OSHPC BARKI TOJIK

Phase II Report: Project Definition Options Dam Safety Part 2: Hydrology & Flood Control

Review of HPI's Design

Figure 3.1 : Plan view - Diversion and spillway structures - HPI scheme

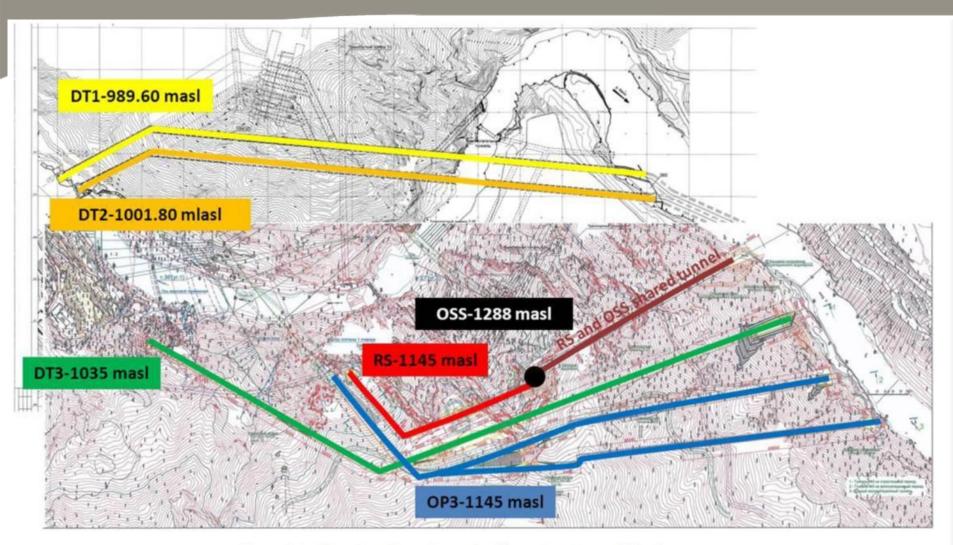
According to the Consultant criteria, several items appear not to be fully safe:

- The level of protection of the cofferdam is not sufficient.
- The waterhead that all structures (temporary or final) have to support is too high.
- The Ionaksh fault is not mentioned and no remedial measures are proposed to cope with its displacements whereas there is a significant construction period of high dependence on DT3.
- Only two independent structures.
- Vortex dissipation devices have not been tested at this scale.
- There is no provision against GLOFs.
- Impact of sedimentation not taken into account.
